Project: PRA-ROCR 10(5)
The purpose of this Amendment is to:

Amendment No. 0002
Project PRA-ROCR 10(5)
Rock Creek Park
Solicitation: DTFH71-16-R-00001

Project Name: Beach Drive from Rock Creek Parkway to Maryland State Line

AMENDMENT NO. 2 ◇1	PMIS NO.	NPS NO.	STATE	PROJECT	SHEET NO.
	044965	821 / 100425	DC	PRA-ROCR 10(5)	D48

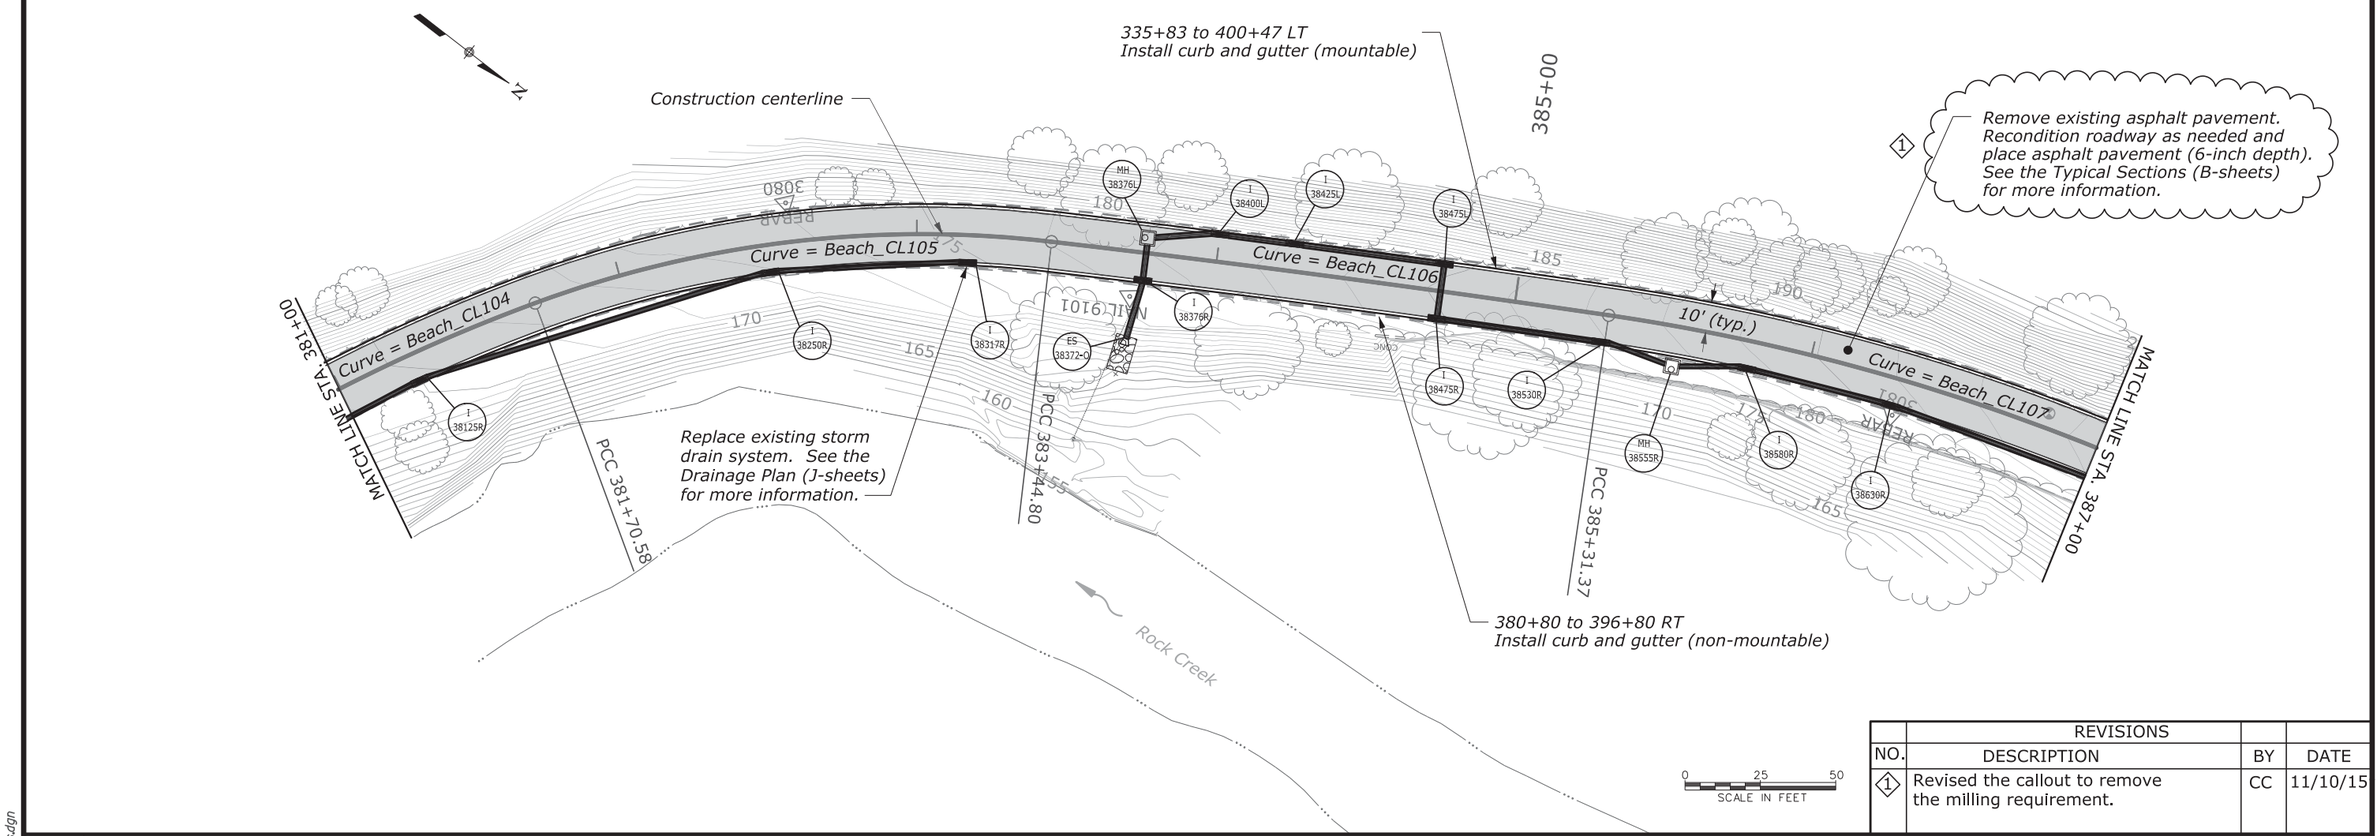
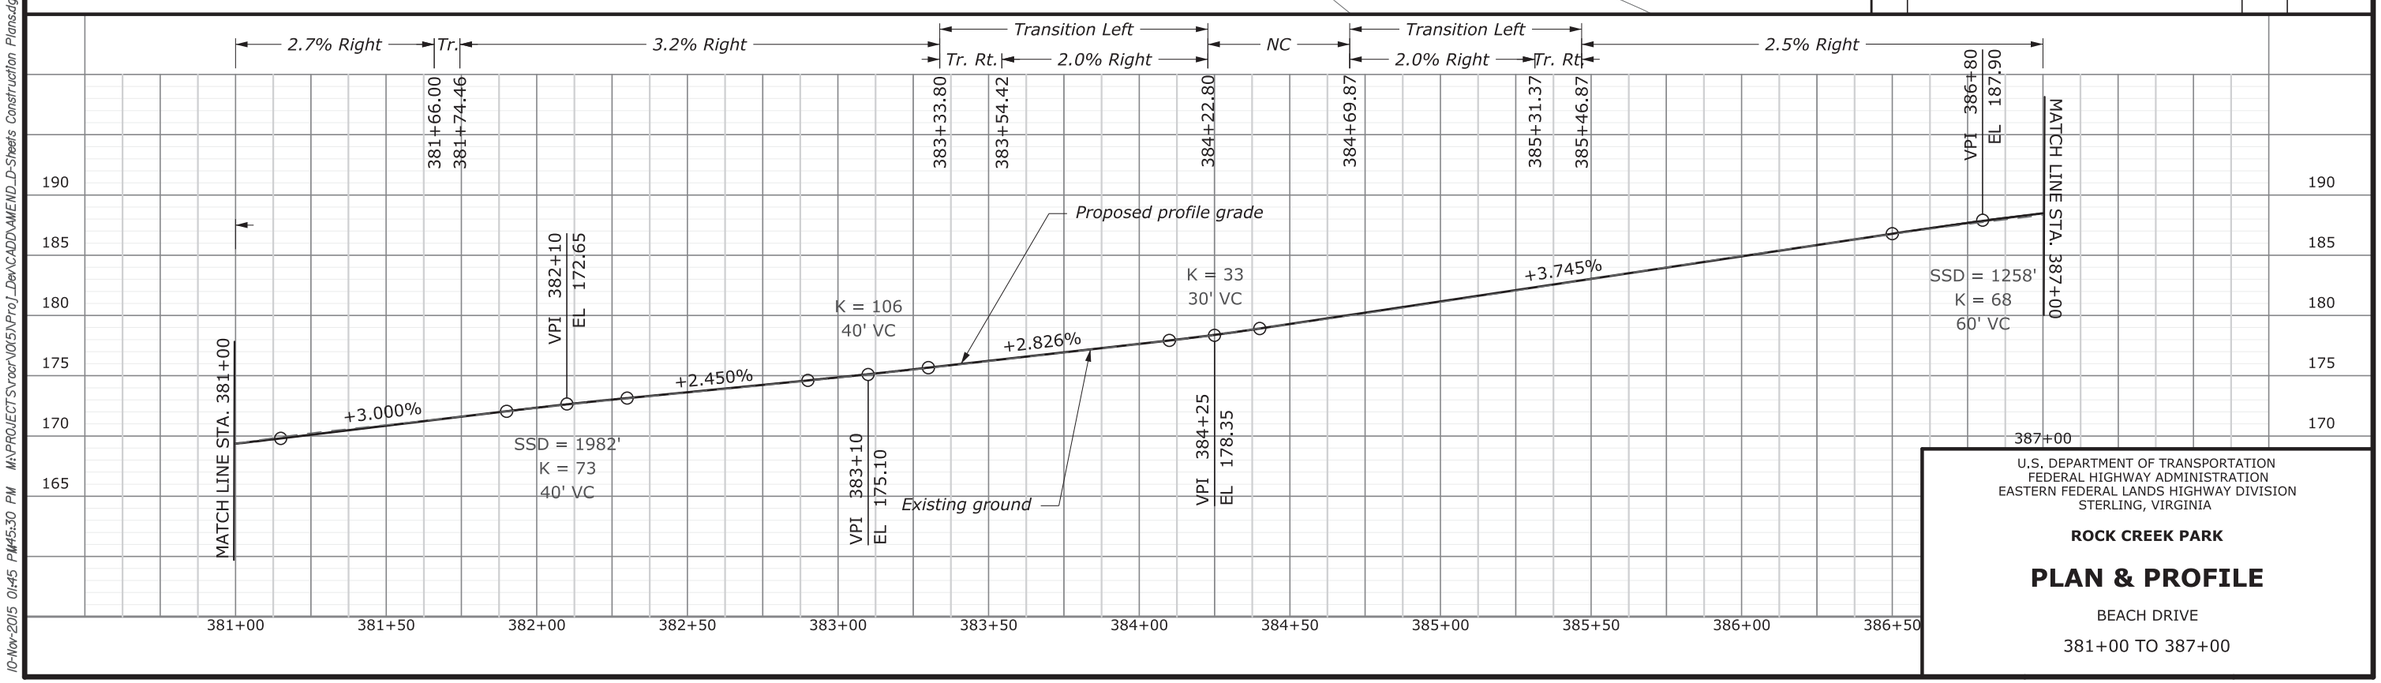
NO.	REVISIONS DESCRIPTION	BY	DATE
◇1	Revised the callout to remove the milling requirement.	CC	11/10/15

AMENDMENT NO. 2 ◇1	PMIS NO.	NPS NO.	STATE	PROJECT	SHEET NO.
	044965	821 / 100425	DC	PRA-ROCR 10(5)	D49

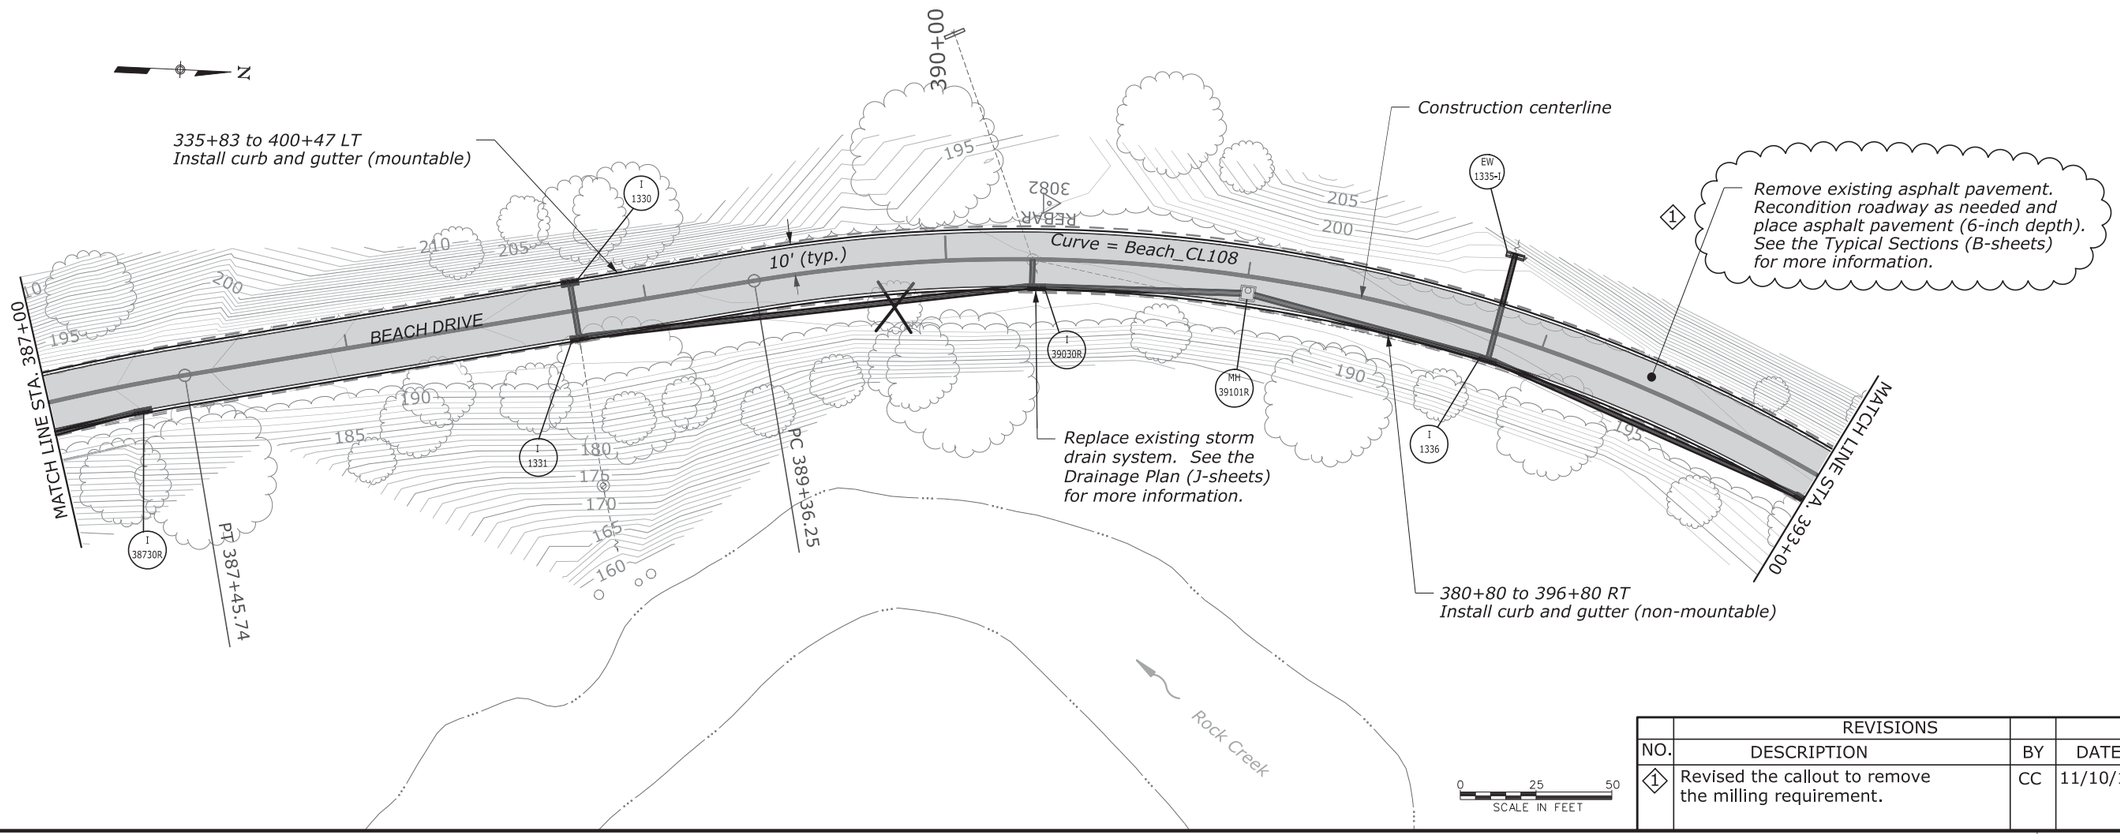
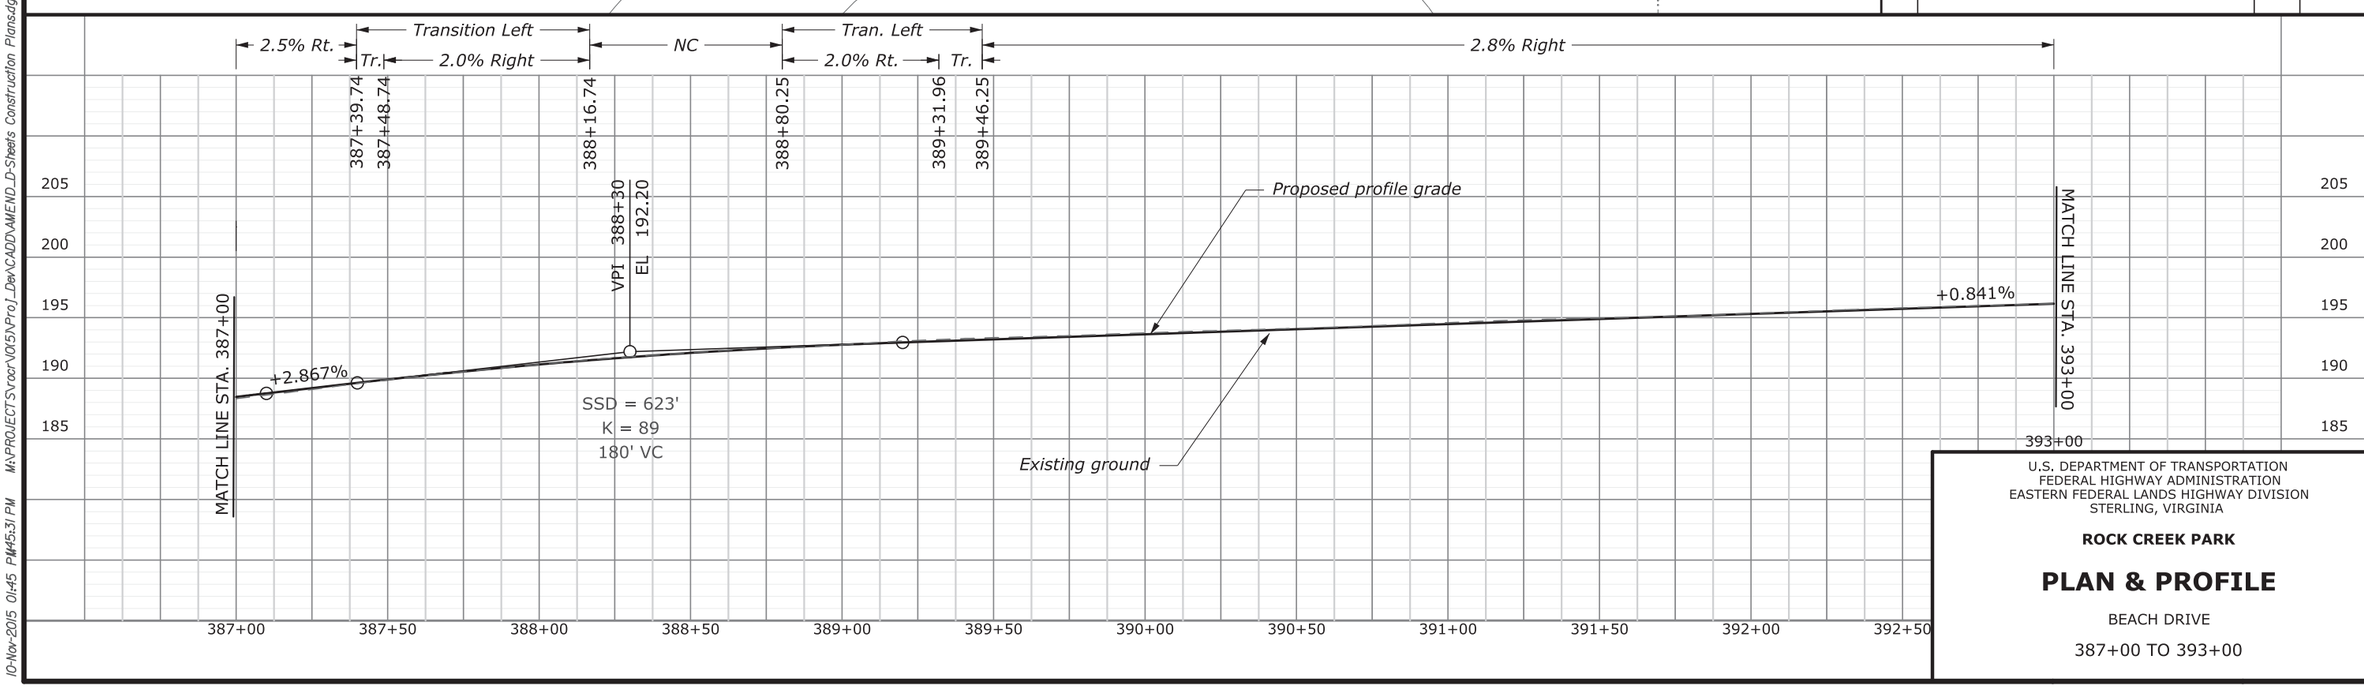
REVISIONS			
NO.	DESCRIPTION	BY	DATE
◇1	Revised the callout to remove the milling requirement.	CC	11/10/15

AMENDMENT NO. 2 ◇1	PMIS NO.	NPS NO.	STATE	PROJECT	SHEET NO.
	044965	821 / 100425	DC	PRA-ROCR 10(5)	D50

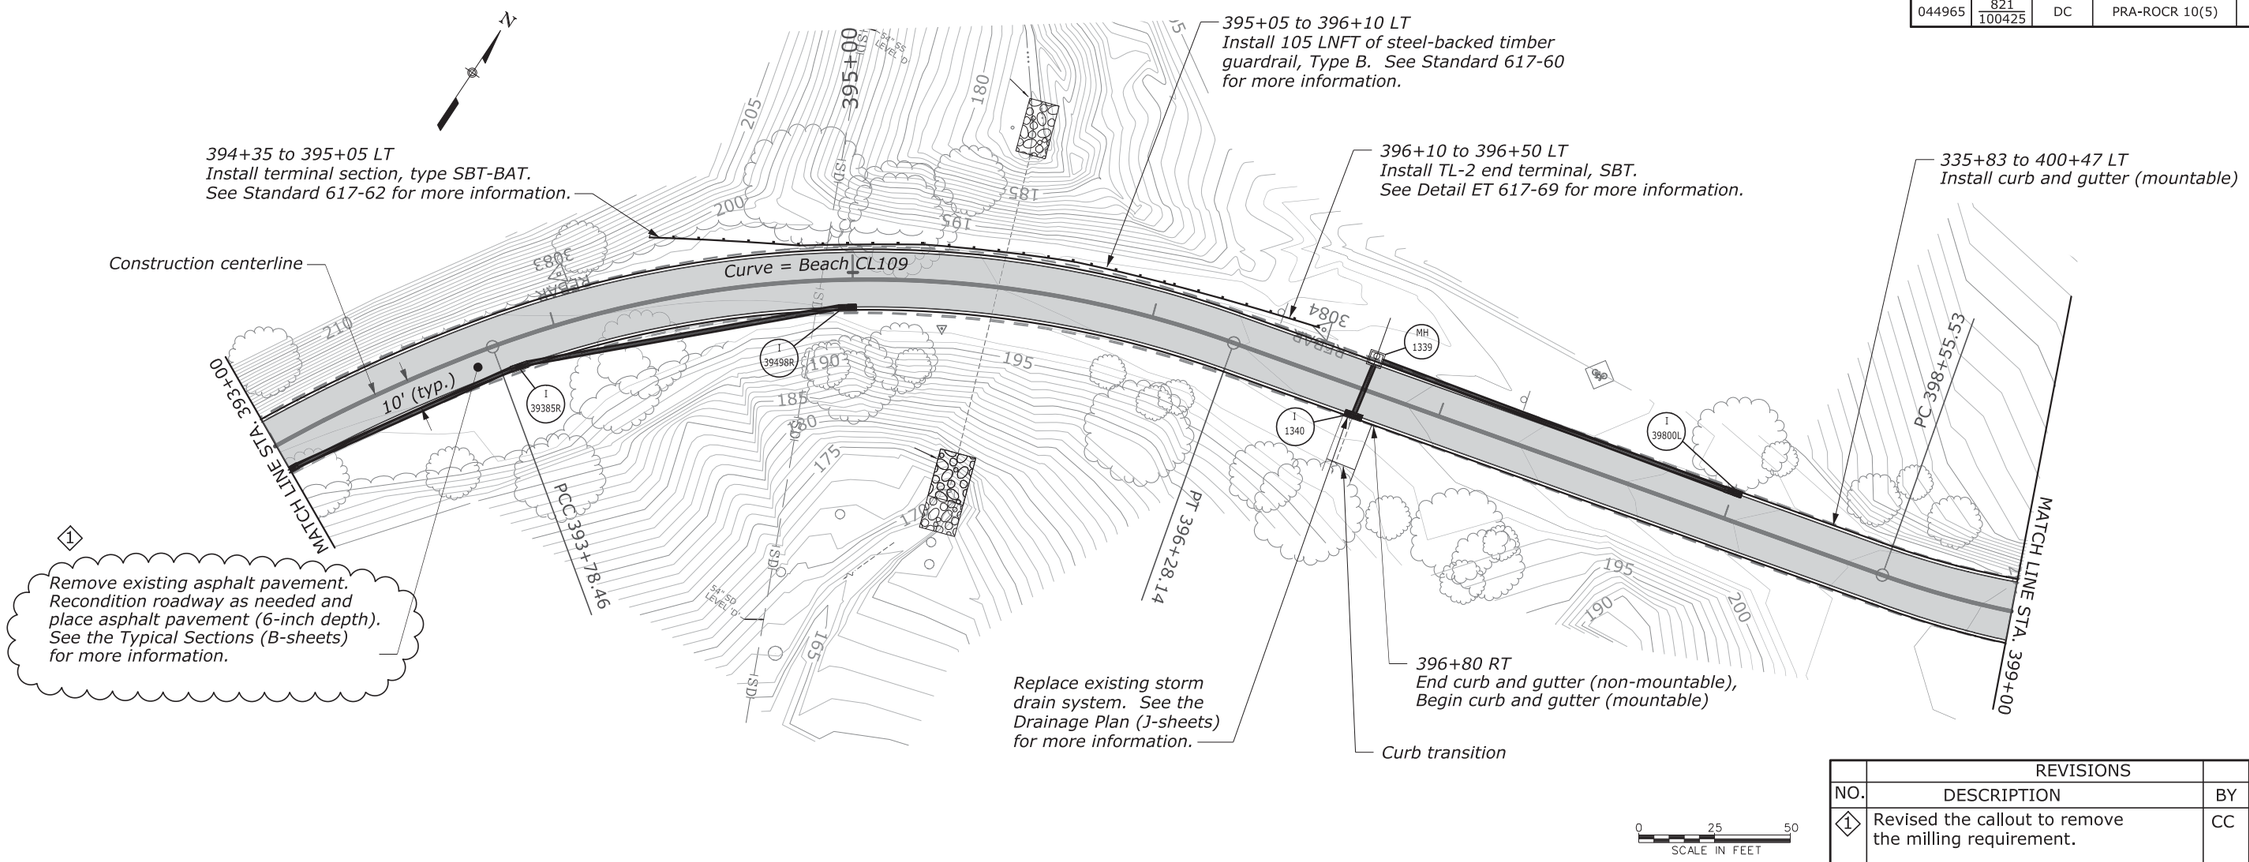
REVISIONS			
NO.	DESCRIPTION	BY	DATE
◇1	Revised the callout to remove the milling requirement.	CC	11/10/15
